ADDENDUM NO. 1

This addendum modifies the Contract Documents dated December, 2022, for the San Lorenzo Valley Water District Redwood Park Pipeline Project, and the work shall be accomplished in accordance with such modifications. This Addendum includes two (2) pages plus three (3) attachments (total of 13 pages).

REDWOOD PARK PIPELINE

C-4.0

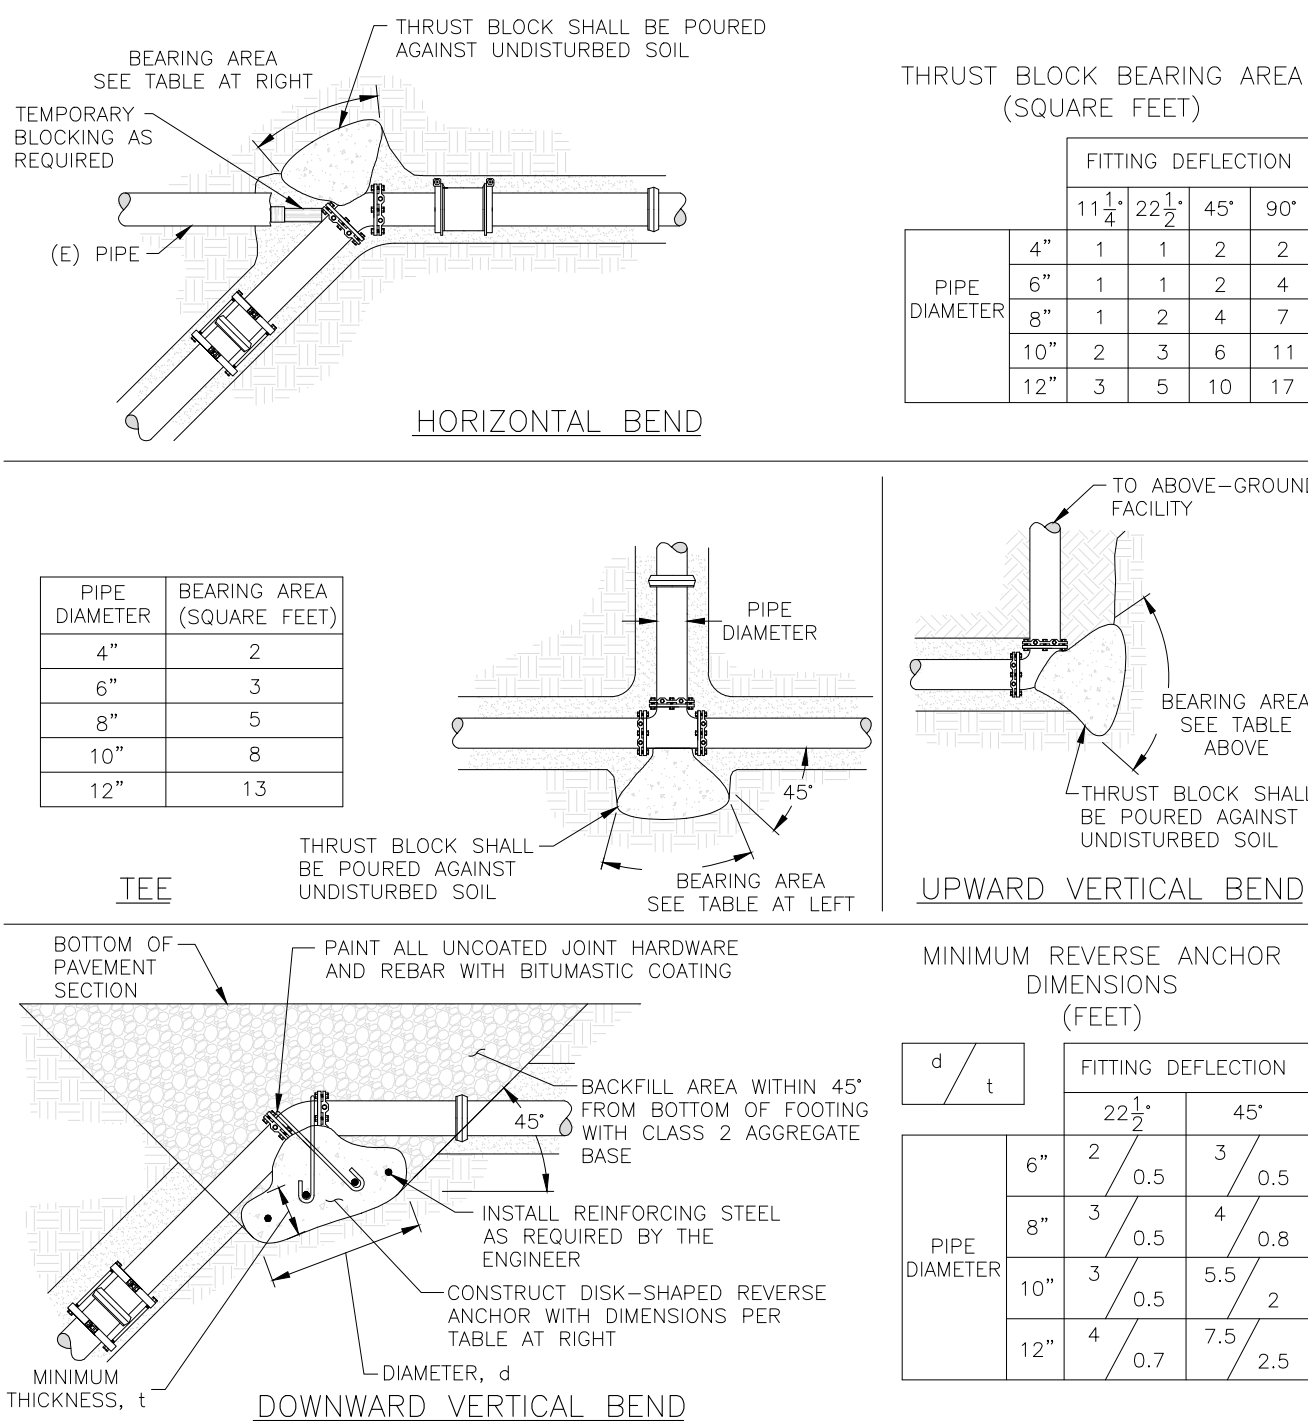
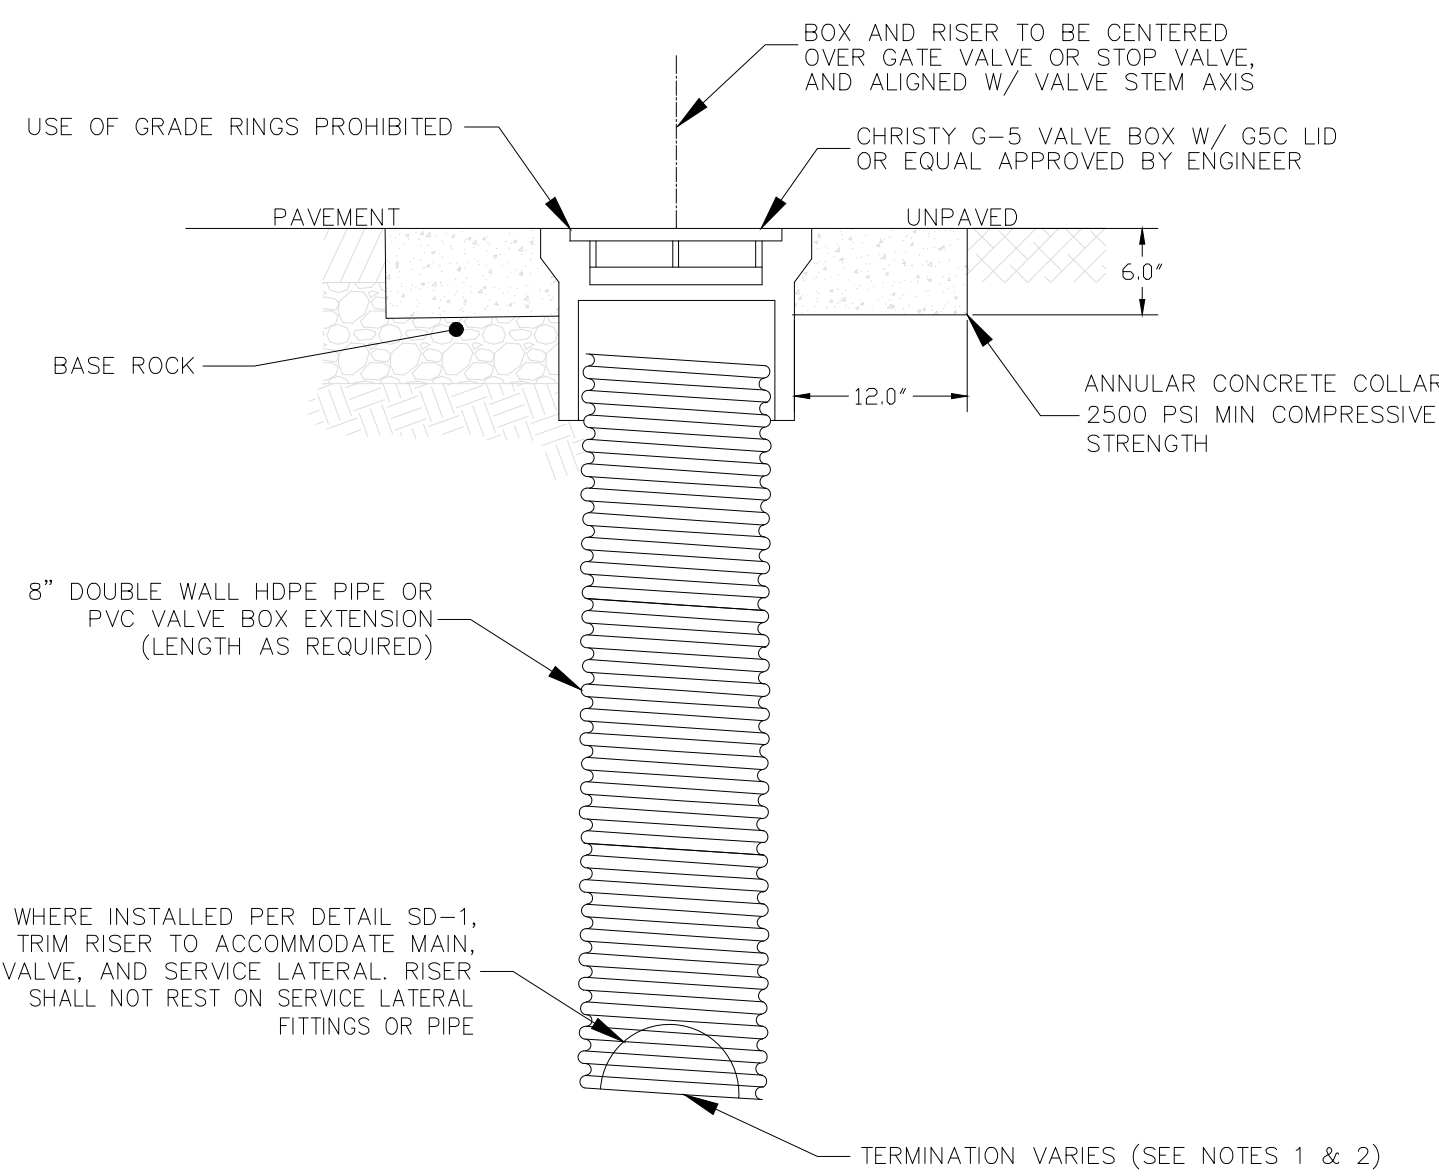
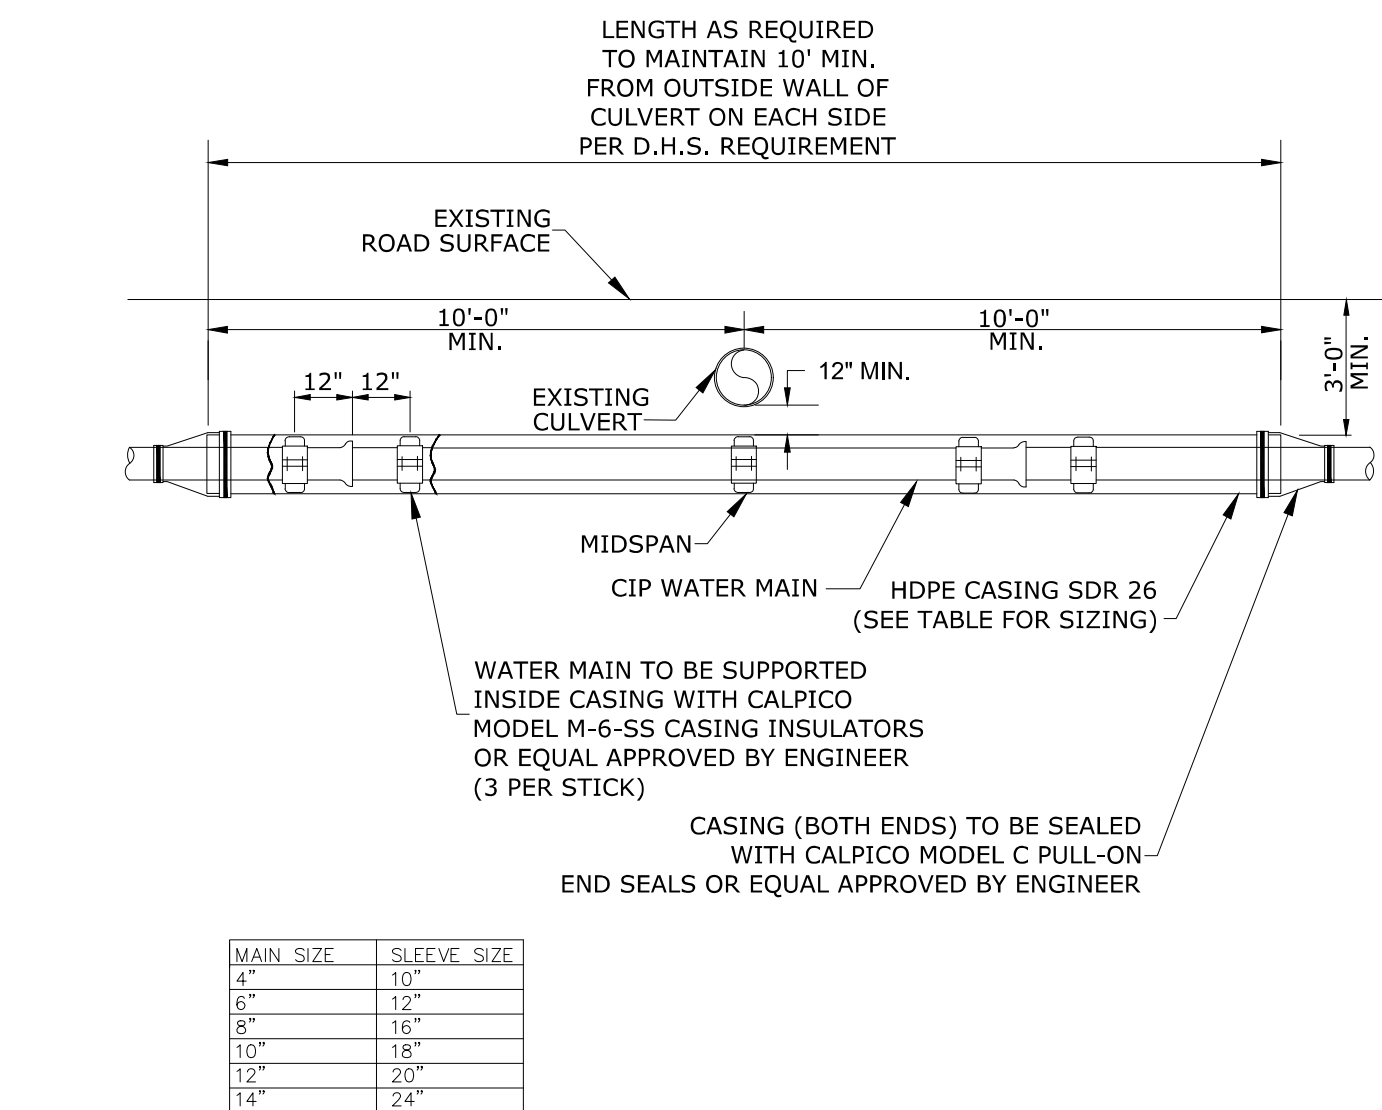
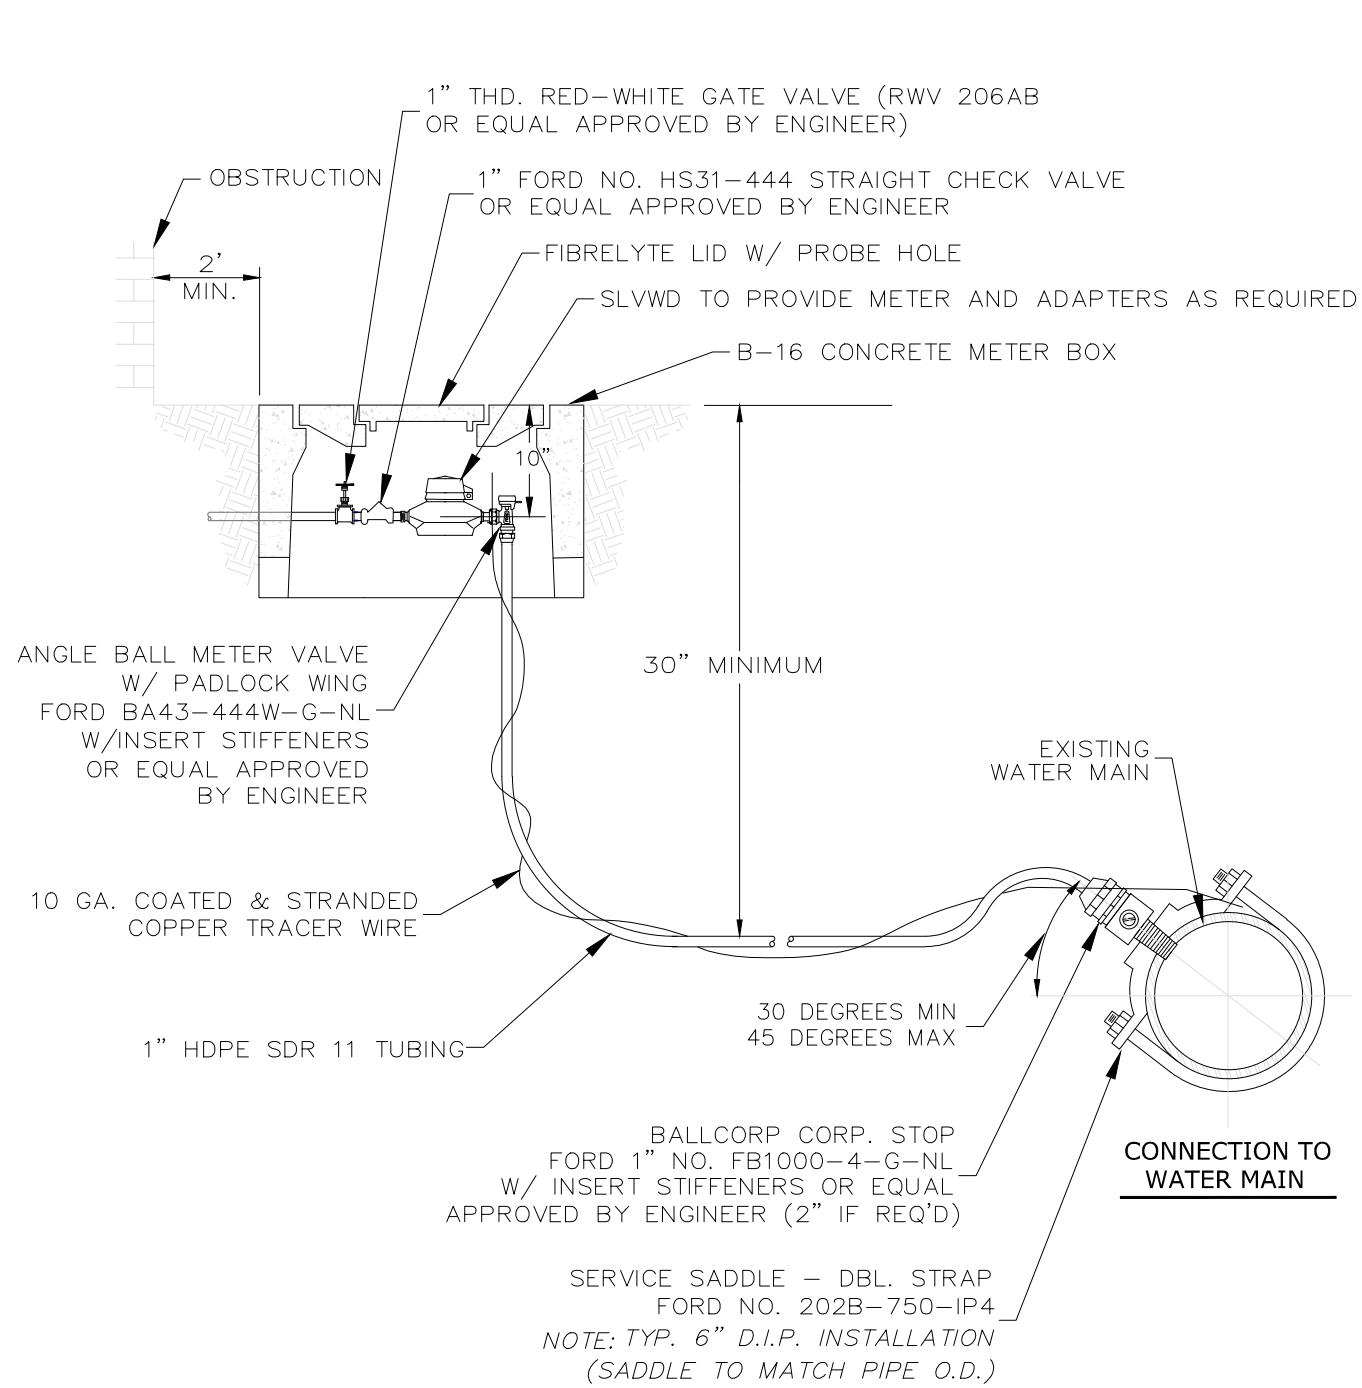
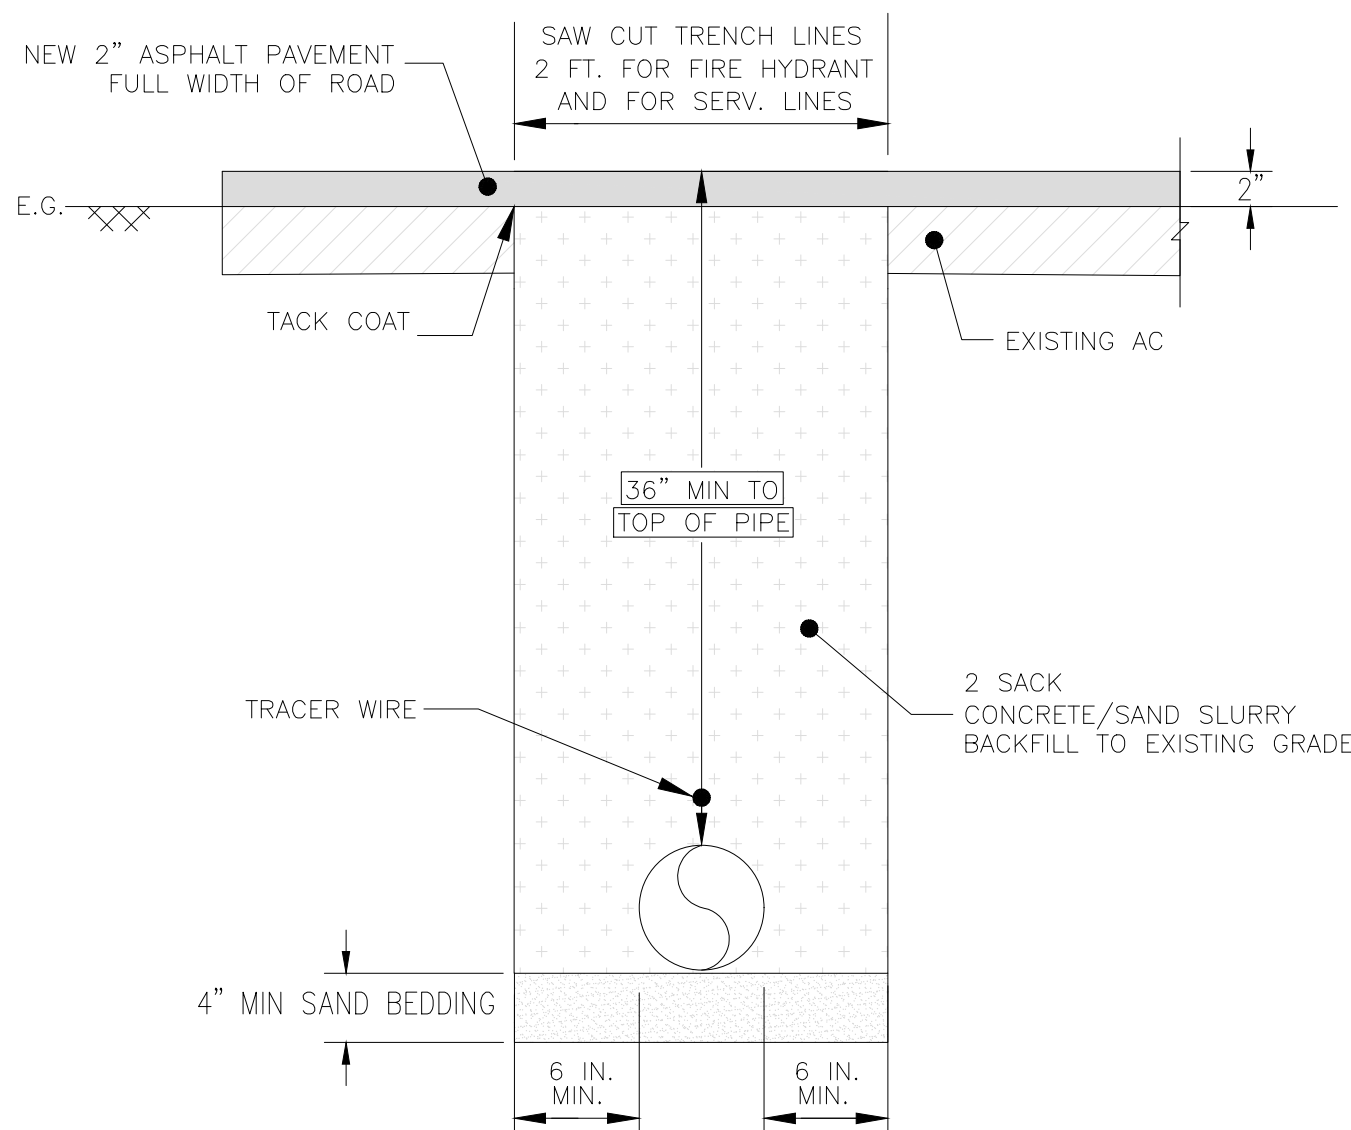
“23. Minimum wall-to-wall separation between pipes is to be 12-inches, unless otherwise specified.”
- B. Sheet C3.0, Proposed Site Plan is revised. The changed sheet is attached.
- C. Sheet C3.1, Proposed Details is revised. The changed sheet is attached.
- D. Sheet C4.0 Utility Details is revised. The changed sheet is attached.
